REVISIONS

PROJECT REFERENCE NO. R-3825B		SHEET NO. 20	
RW SHEET NO.			
ROADWAY DESIGN ENGINEER	HYDRAULICS ENGINEER		NOT A CERTIFIED DOCUMENT AS TO THE ORIGINAL DOCUMENT
NOT A CERTIFIED DOCUMENT AS TO THE ORIGINAL DOCUMENT		NOT A CERTIFIED DOCUMENT AS TO THE ORIGINAL DOCUMENT	
THIS DOCUMENT ORIGINALLY ISSUED AND SEALED BY:		THIS DOCUMENT ORIGINALLY ISSUED AND SEALED BY:	
EDWARD GLENN EDENS, JR. 18470 ON 08/09/2018		MEME D. BUSCEMI 037863 ON 08/09/2018	
THIS DOCUMENT IS ONLY CERTIFIED AS TO THE REVISIONS.		THIS DOCUMENT IS ONLY CERTIFIED AS TO THE REVISIONS.	
DOCUMENT NOT CONSIDERED FINAL UNLESS ALL SIGNATURES COMPLETED			
ROADWAY DESIGN ENGINEER	HYDRAULICS ENGINEER		
8/17/2020	8/18/2020		
Tanya J. White		Matthew J. York, P.E.	
FOR REVISIONS ONLY		FOR REVISIONS ONLY

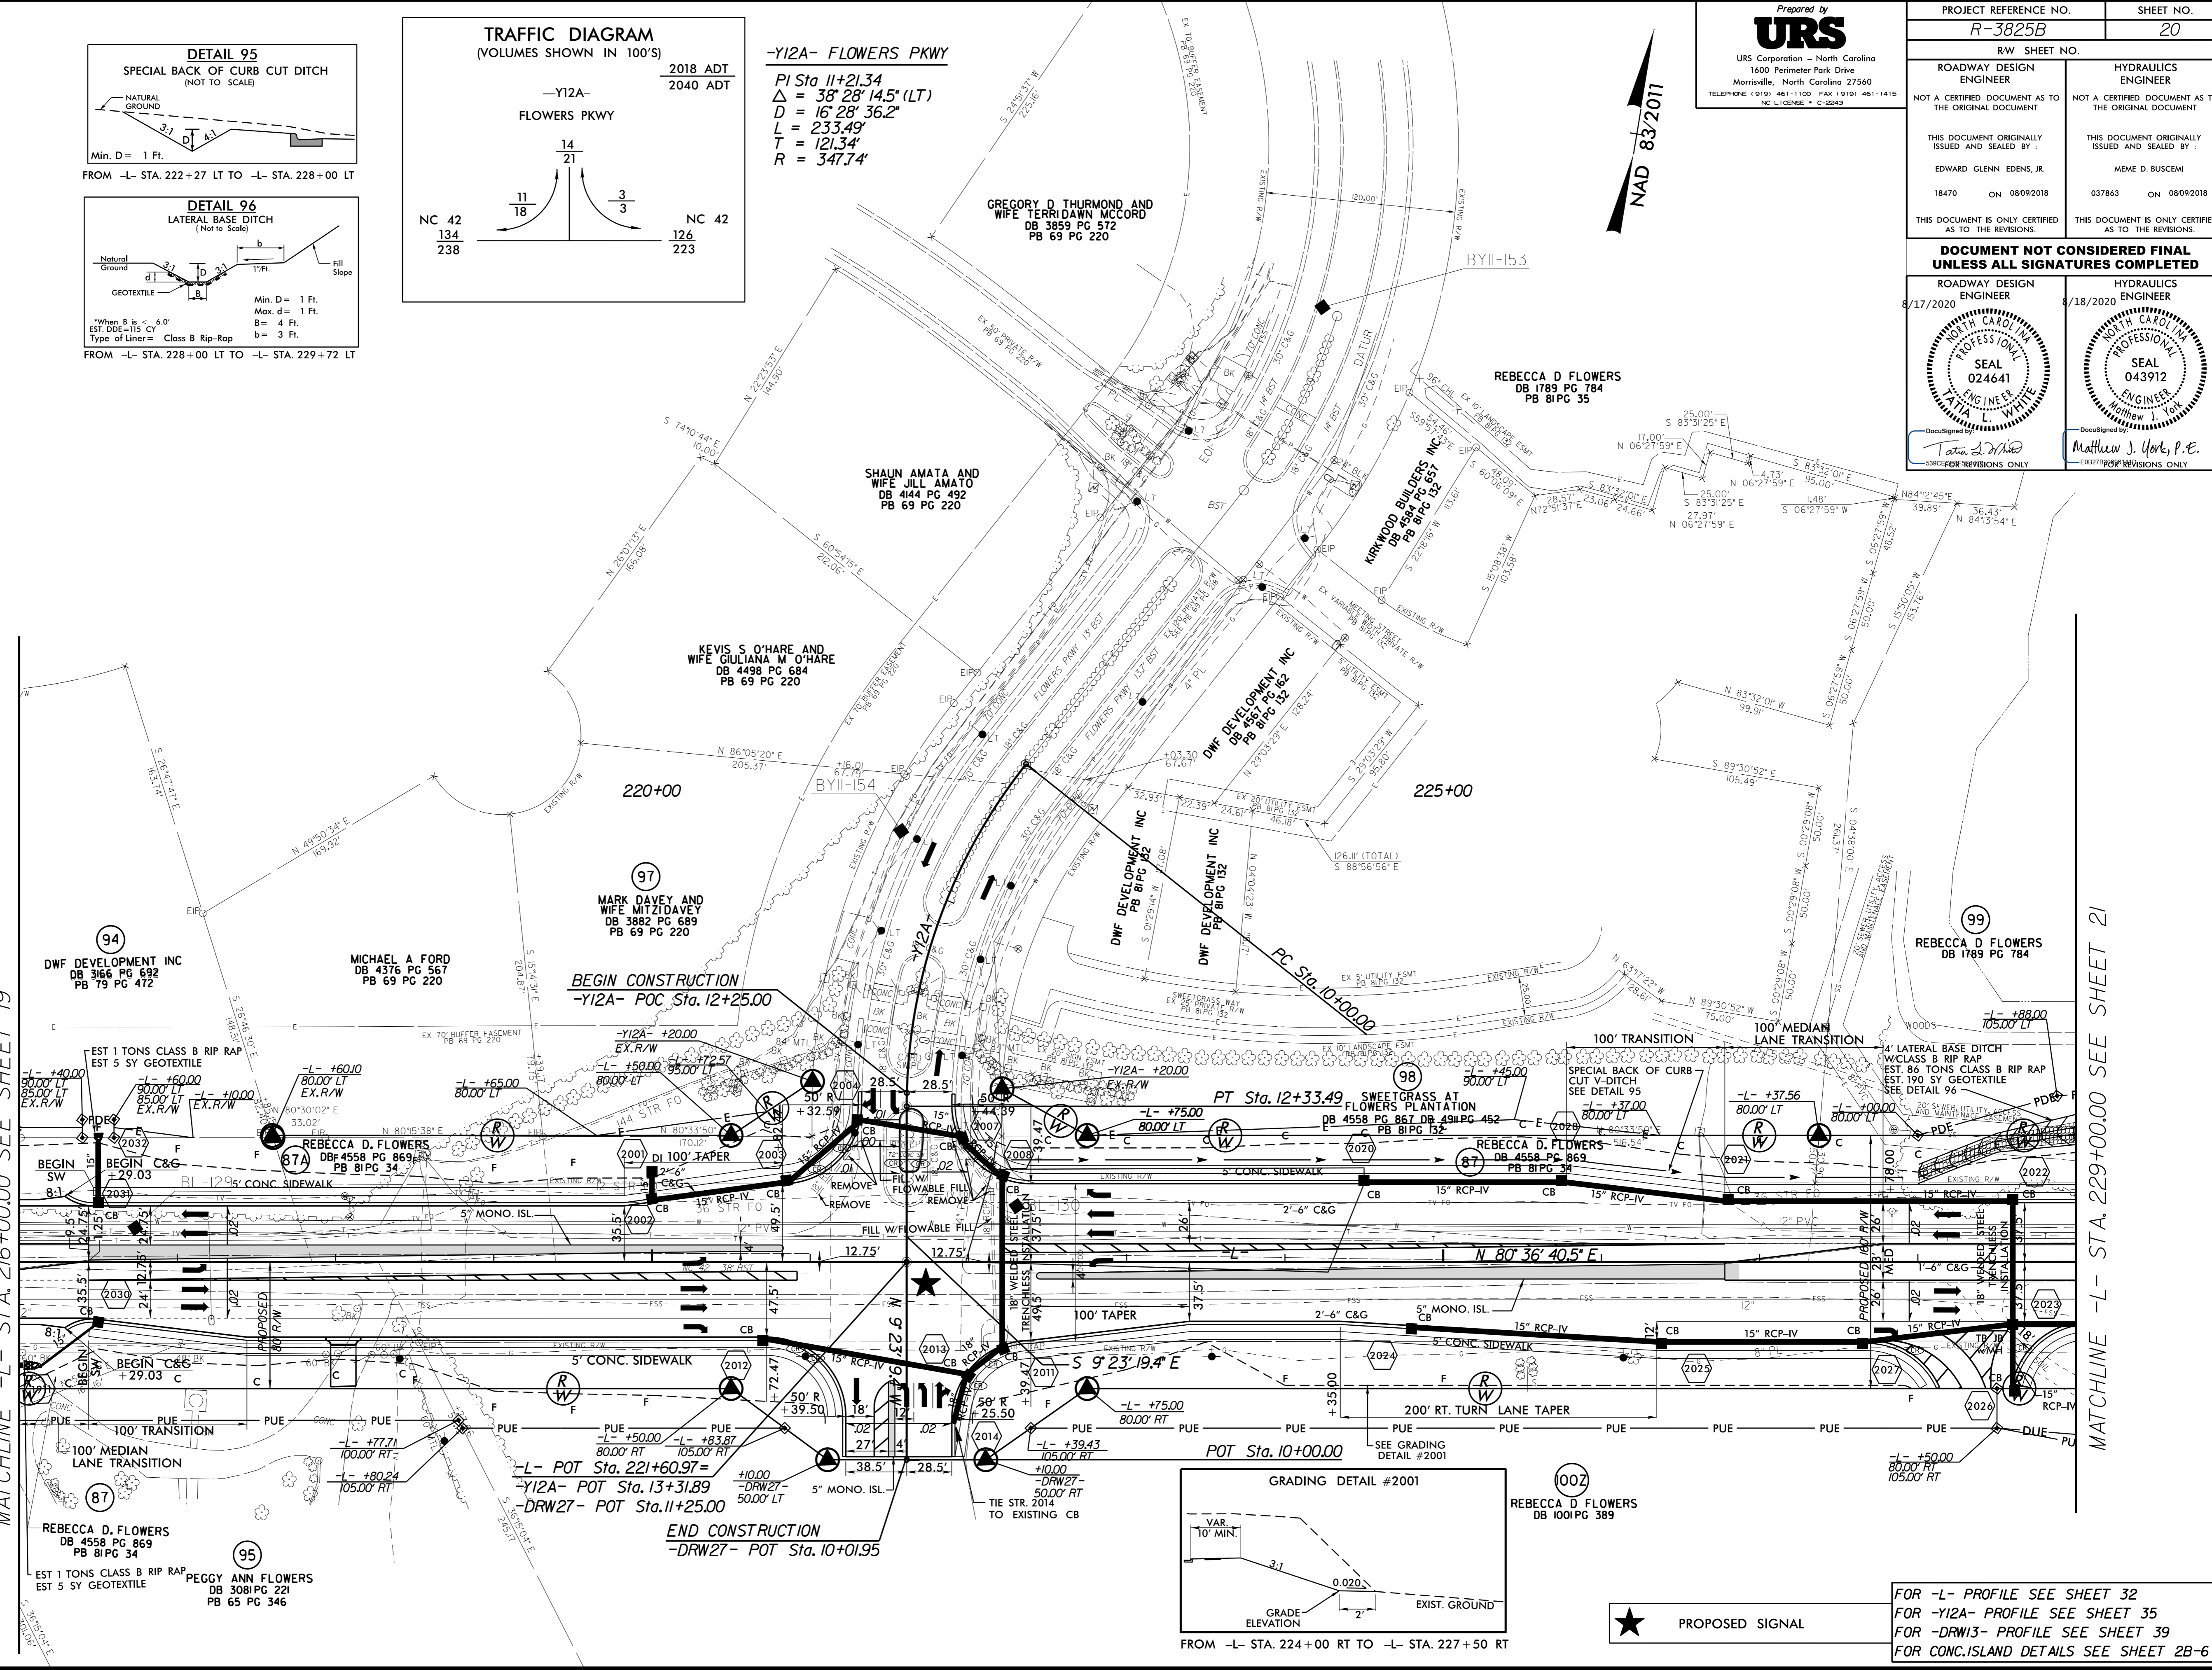
1 - ROW, PUE, PDE, AND EASEMENTS UPDATED ON PARCEL 100 FROM STA. 218+77 TO 244+77 (10/12/2018) TLH
 10/16/2019 - CONSTRUCTION REVISION: ADDED A RIGHT TURN FROM -L- STATION 224+35.00 TO 229+08.67 RIGHT AND REMOVED -DRW13- AT -L- STA. 228+86.87 TO 229+52.33.
 HYDRAULICS WAS ALSO REVISED IN THESE AREAS. HN
 08/17/2020 - CONSTRUCTION REVISION: ADDED AN EXCLUSIVE LEFT TURN LANE TO -DRW27- AND -Y12A-, WIDENED THE INGRESS RADIUS FOR THE DRIVEWAY AT -L- STATION 227+84,
 REVISED THE BERM AND SLOPES FROM -L- STA. 224+00 TO 227+50 RT. TO TIE TO THE DEVELOPER'S GRADING PLAN, AND ADDED
 GRADING DETAIL #2001. THE ASSOCIATED DRAINAGE WAS UPDATED. HN
